**THE
NATIONAL
BOARD**
OF BOILER AND
PRESSURE VESSEL
INSPECTORS

NATIONAL BOARD SUBCOMMITTEE INSPECTION

AGENDA

Meeting of January 13th, 2021
San Antonio, TX

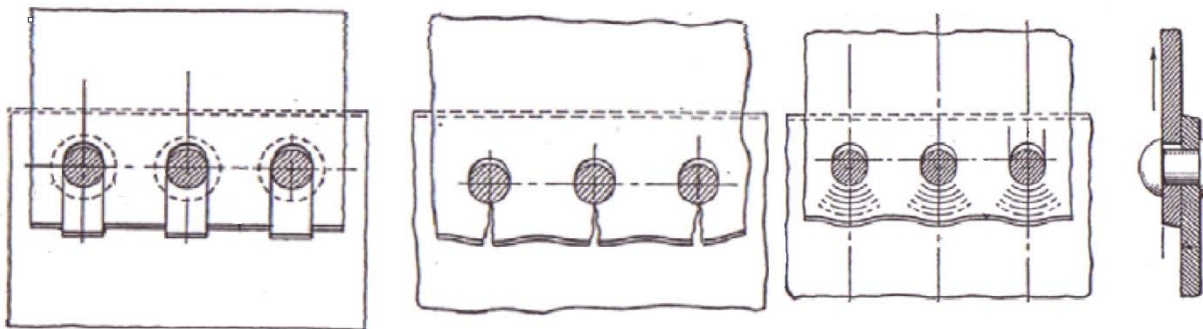
Figure S2.10.2.3 illustrates visual indicators of (c), (d), (e). Inspection shall visually inspect for cracked or stressed plate material along a riveted joint. Indications of failure shall be monitored or repaired, at the discretion of the jurisdiction.

Note: Good engineering practice requires that the lap of plate outside rivet holes, measured from the outer edge of the rivet holes to the edge of the plate must be at least equal to the diameter of the rivet hole.
